BULLETIN NO. 33

JEFFERSON LAB

TECHNICAL ENGINEERING & DEVELOPMENT FACILITY
(TEDF TWO)

Bulletin No.33
Project No. 20080400
March 04, 2011

**EWING
COLE**

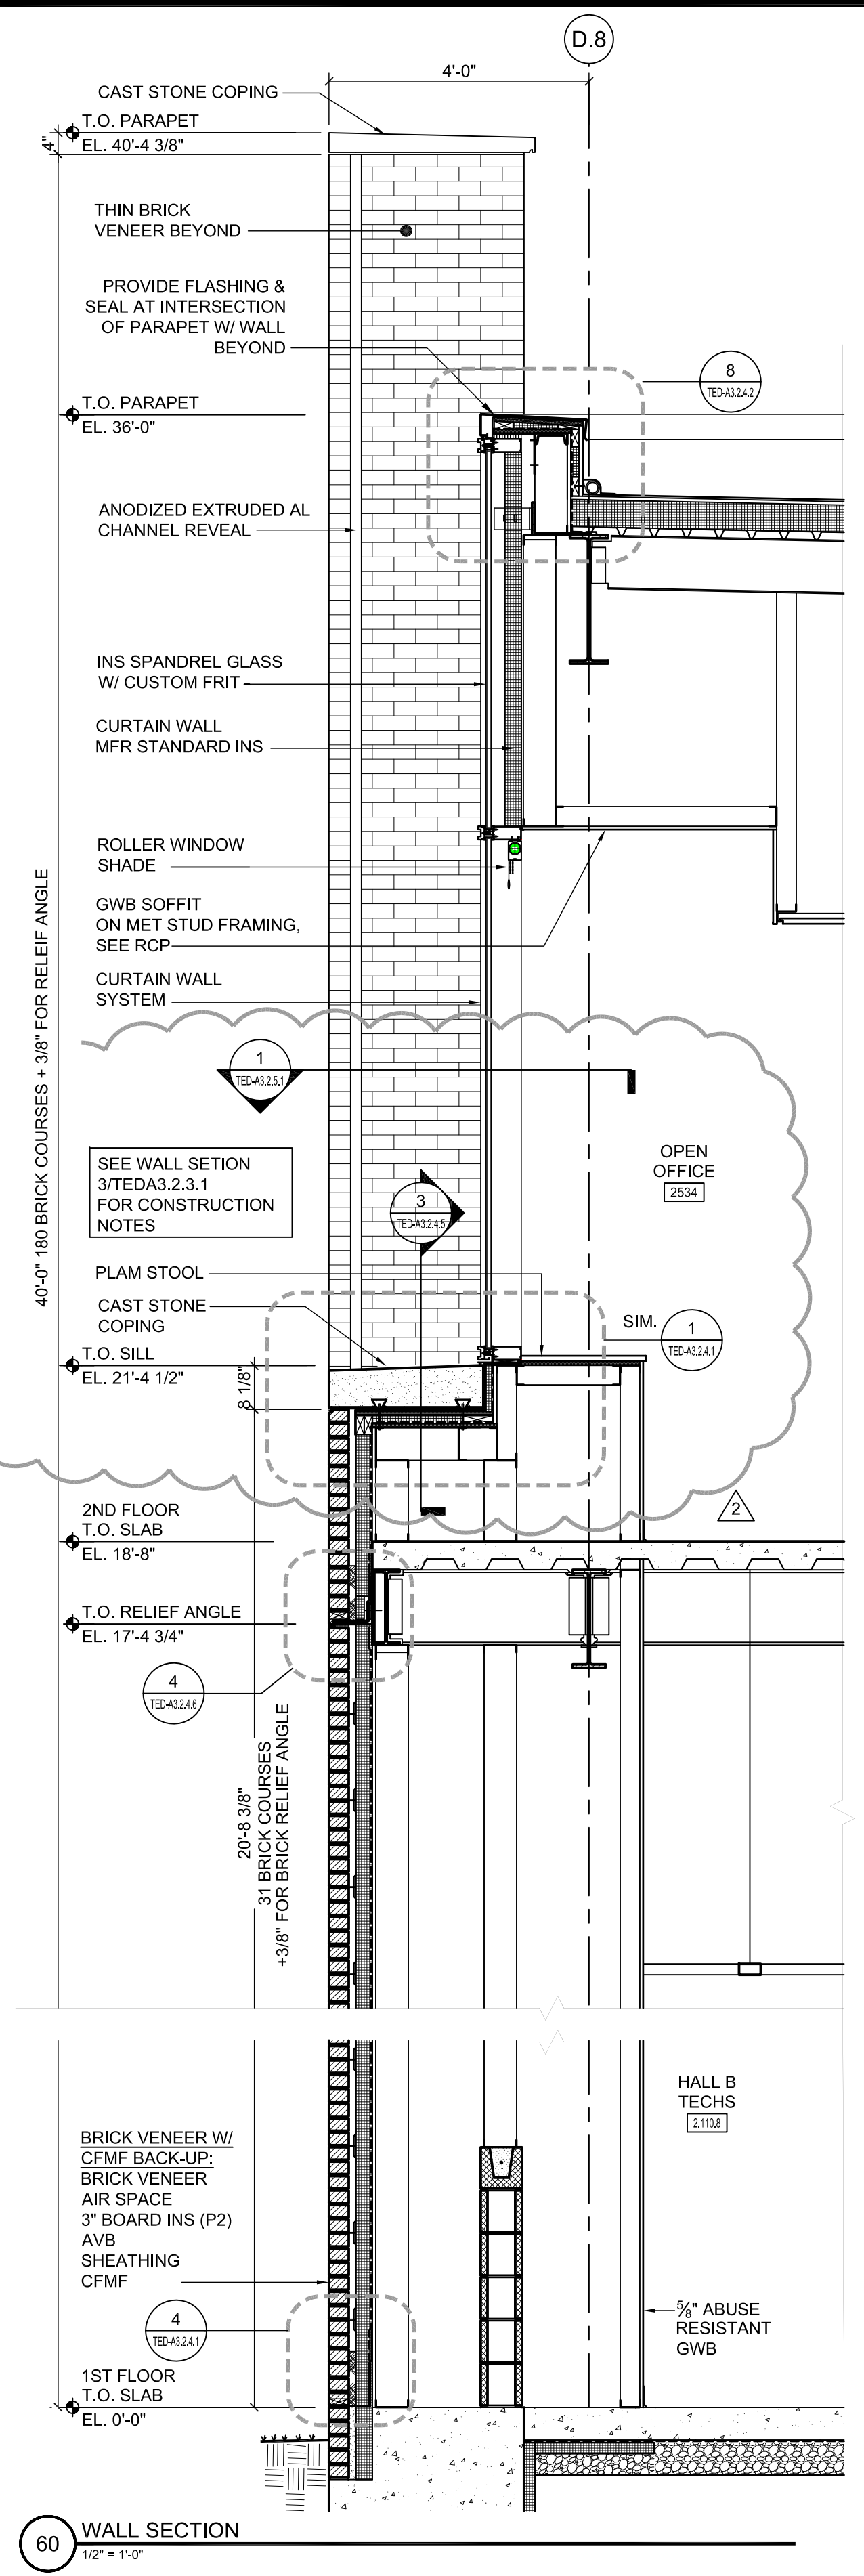
1. Revised wall sections 58 & 60/TED-A3.2.3.16

TITLE: TED BUILDING SECTION DETAILS			
SCALE 3" = 1'-0"	DRAWING NUMBER 100024-178-A160-STE	SHEET TED-A3.2.4.1	REV -

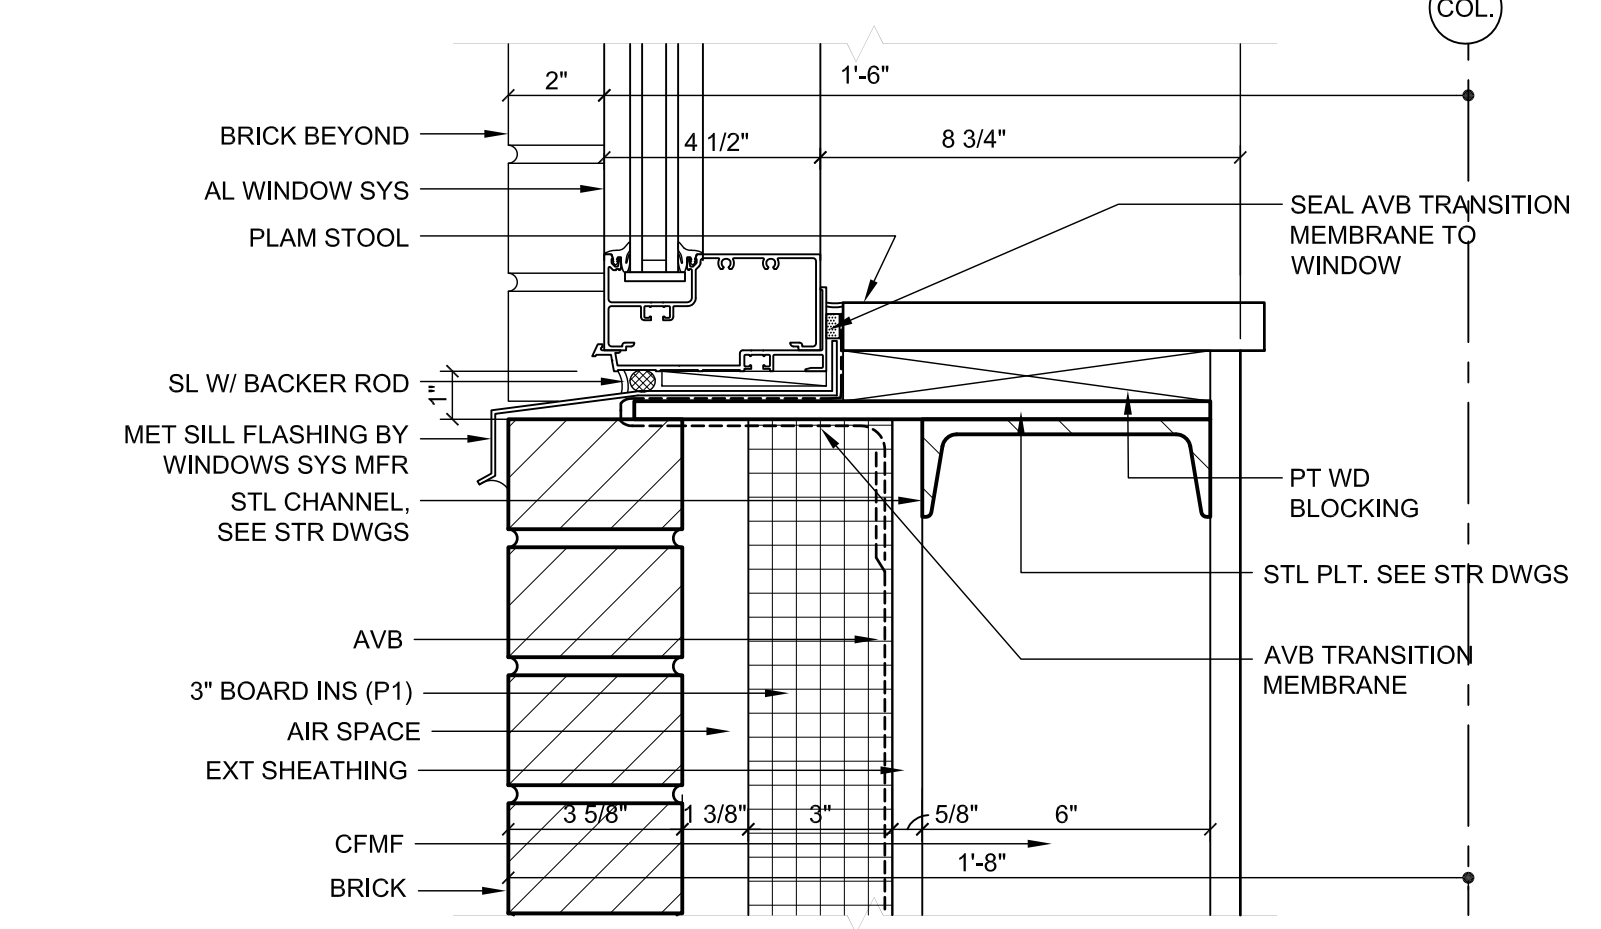
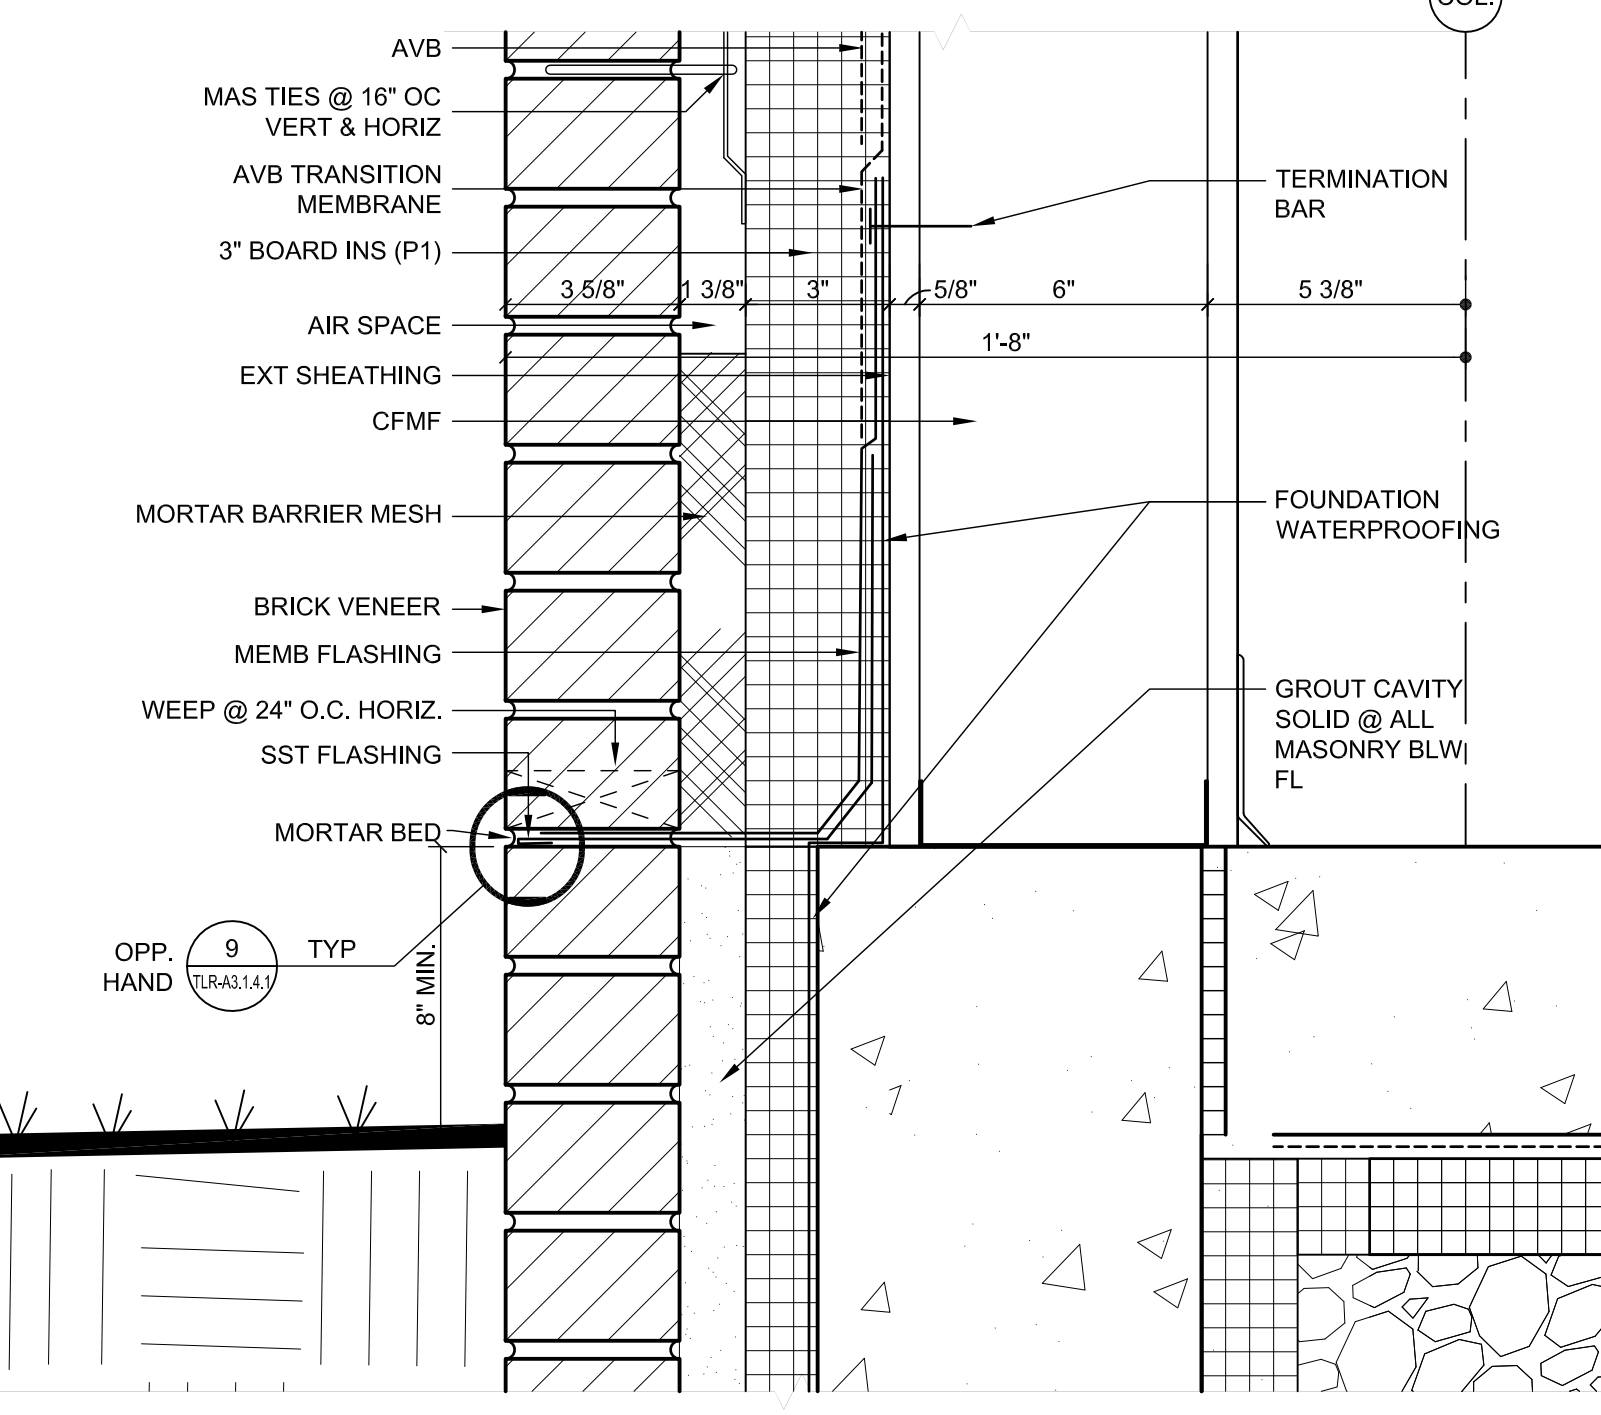
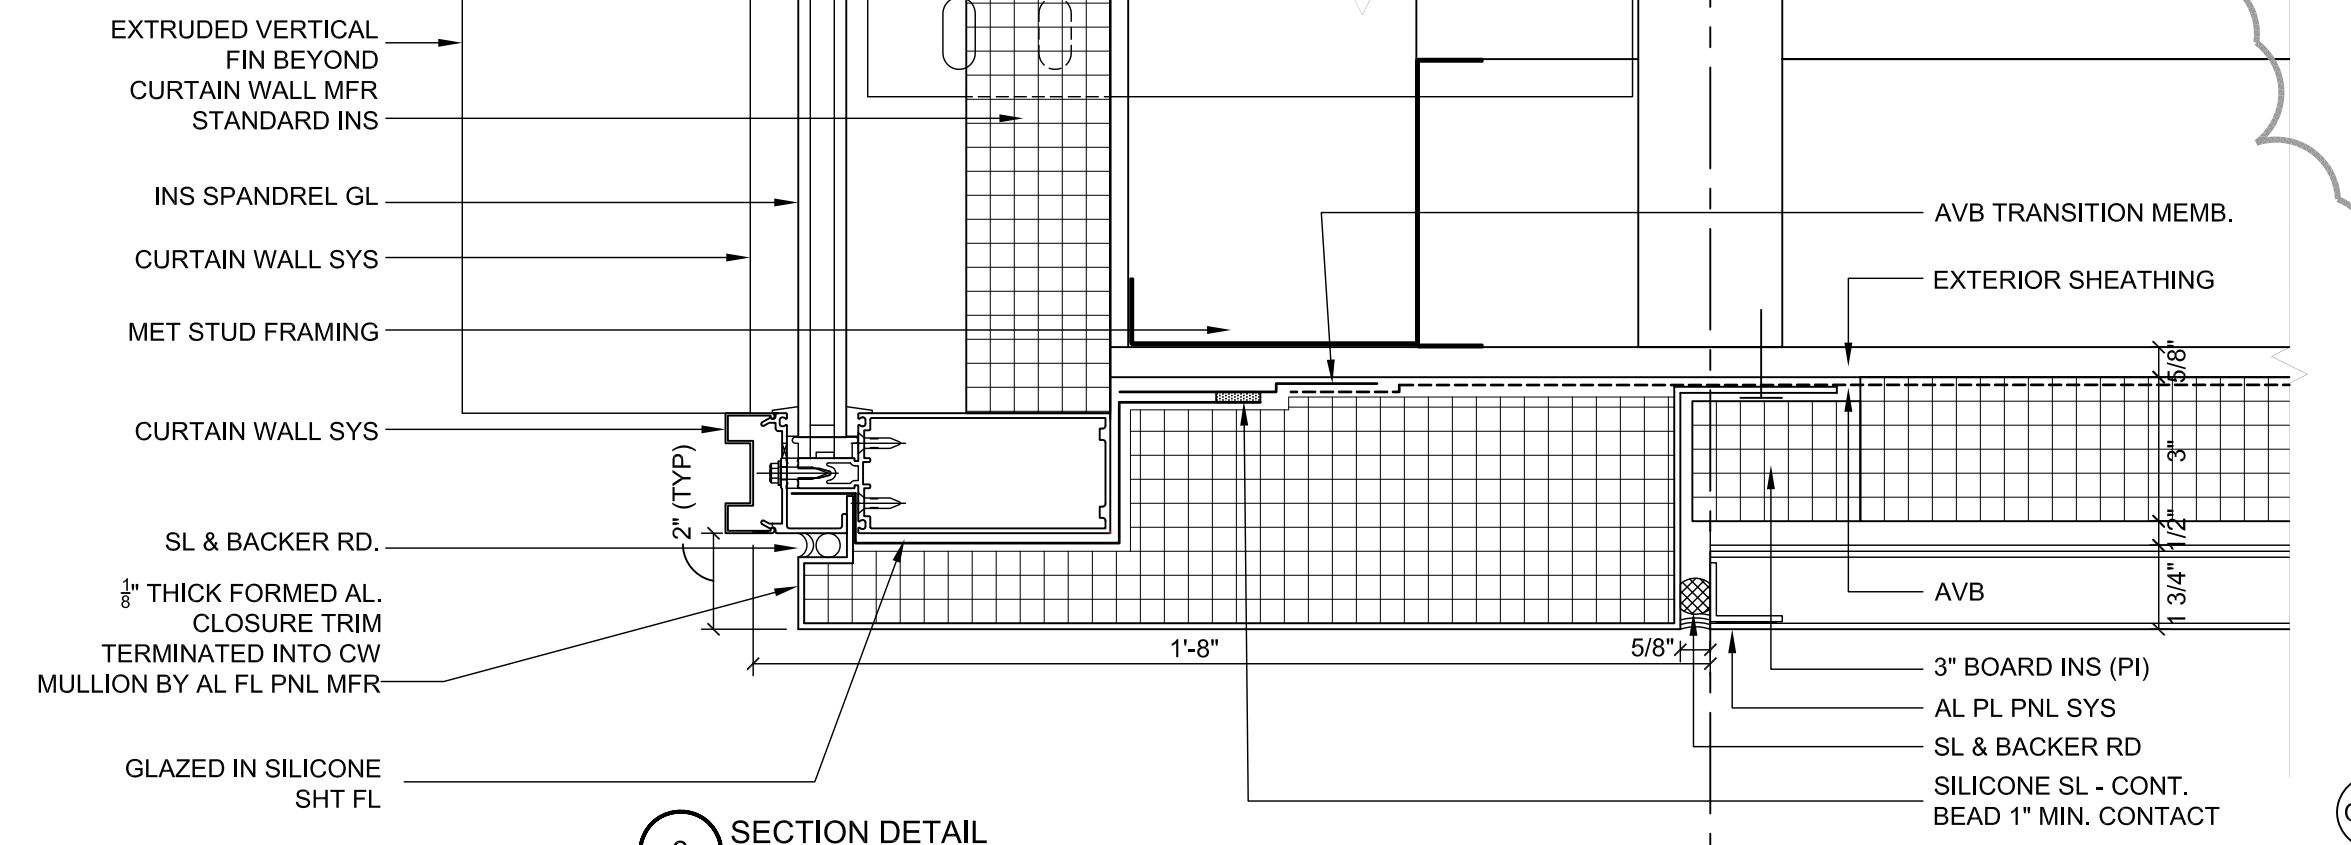
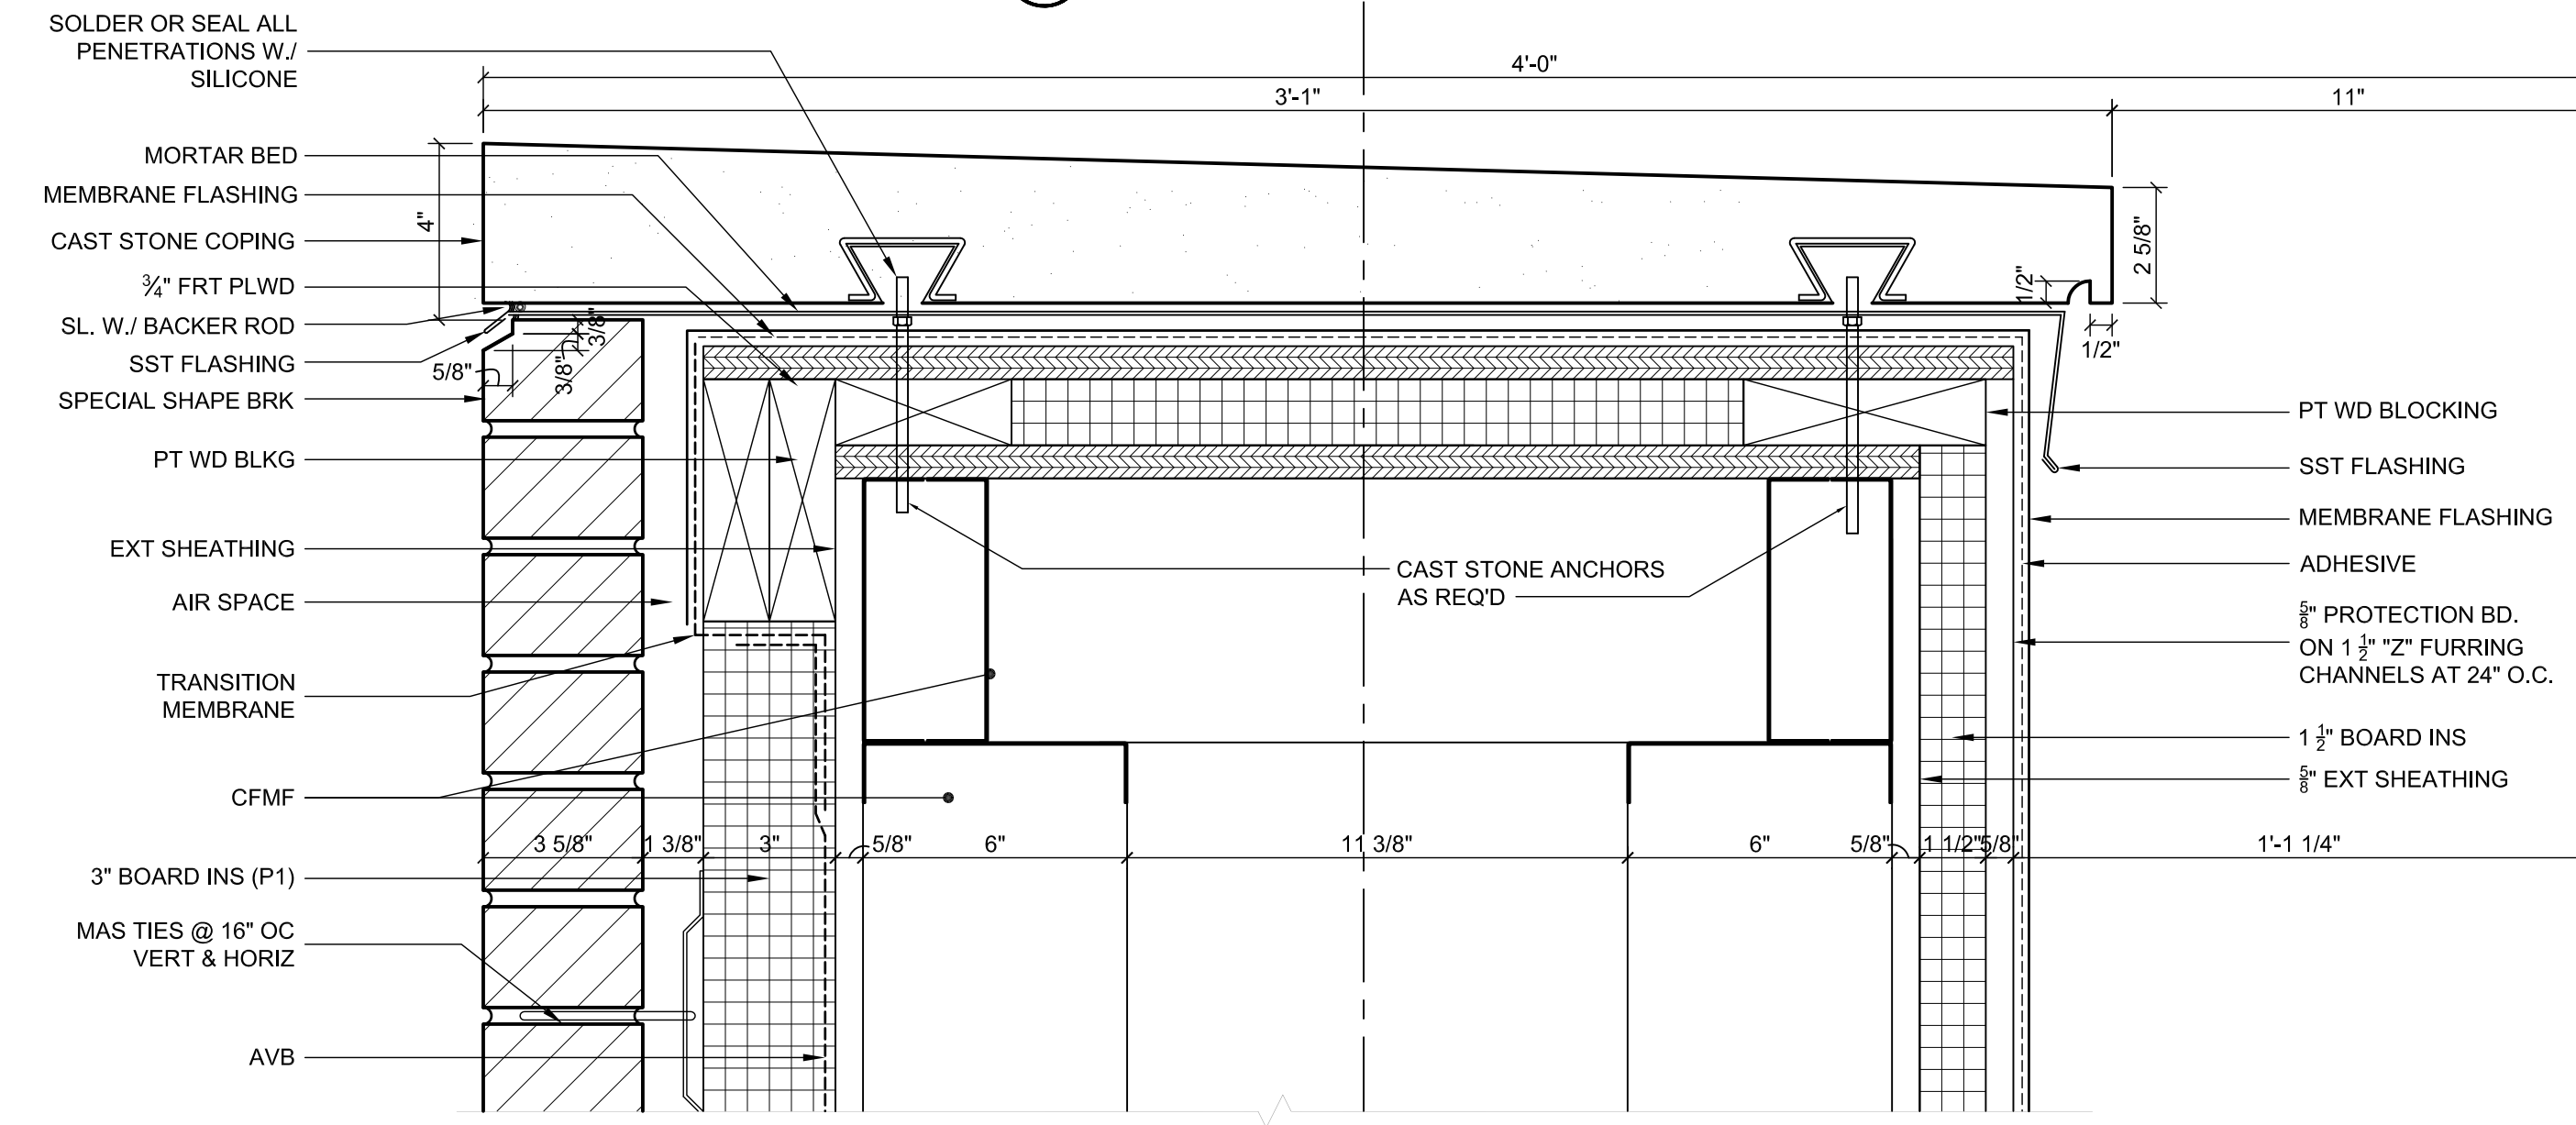
1. Revised section details
